DSO9064A-08

Information Only Service Note

DSO9064A – Infiniium DSO, 600MHz, 10/20 GSa/s, 4Ch

Here are some screenshots of the issue:

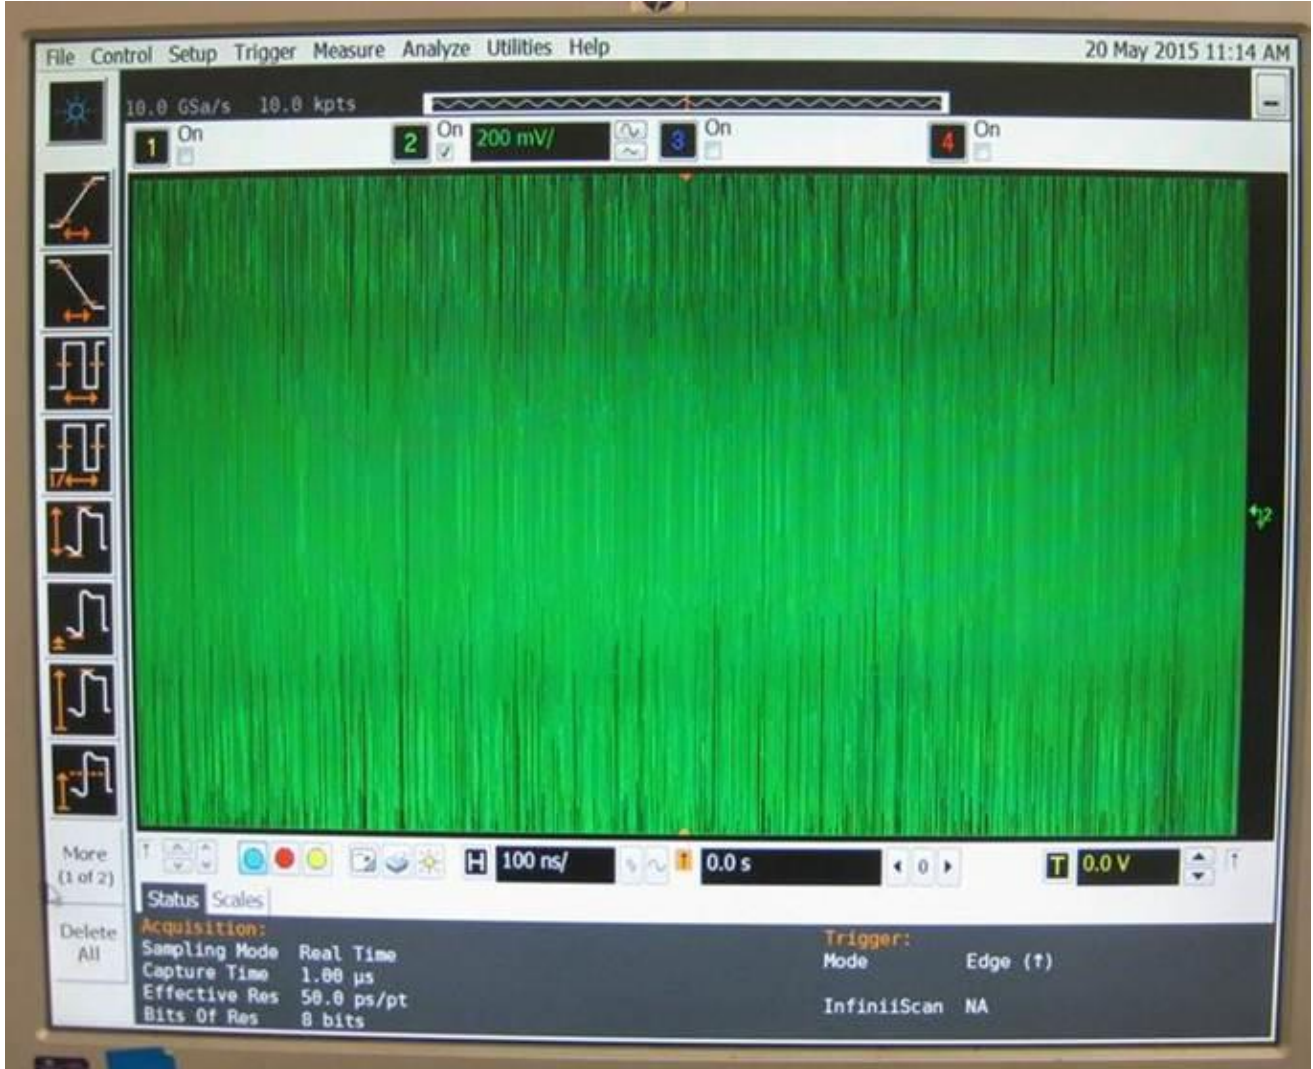
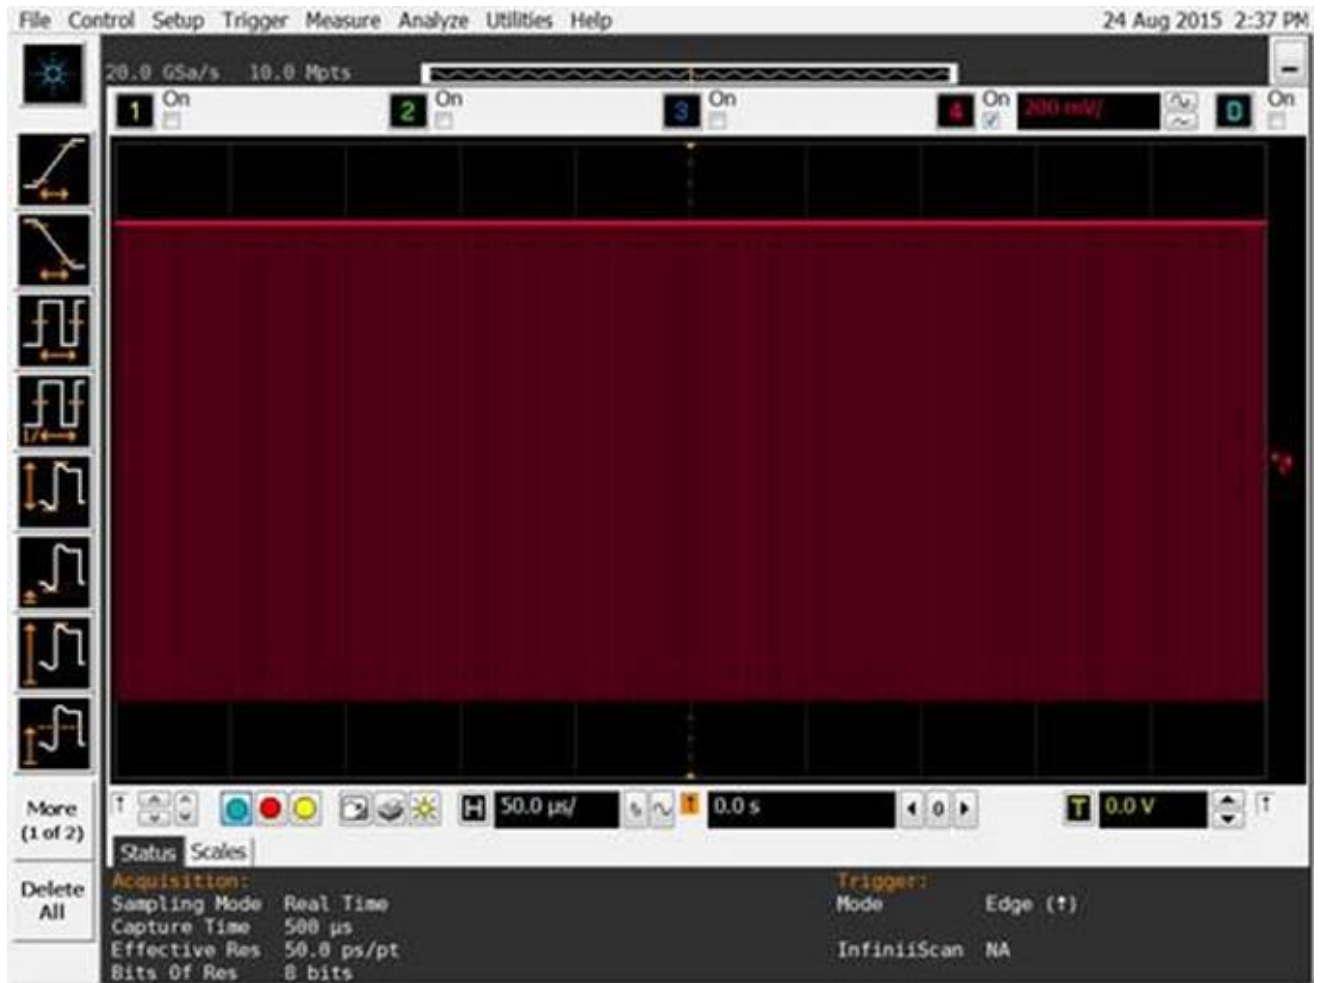
1. Noise appears all over the screen after performing service/user calibration.
2. The noise on full screen could happen on any channel in 50 Ohm impedance on certain vertical settings. Some instances occurs at 200mV/div and not on other settings, whereas some occur at 10mV/div and not on other settings.

Solution/Action:
Install revision of software 5.50.0033 or higher.
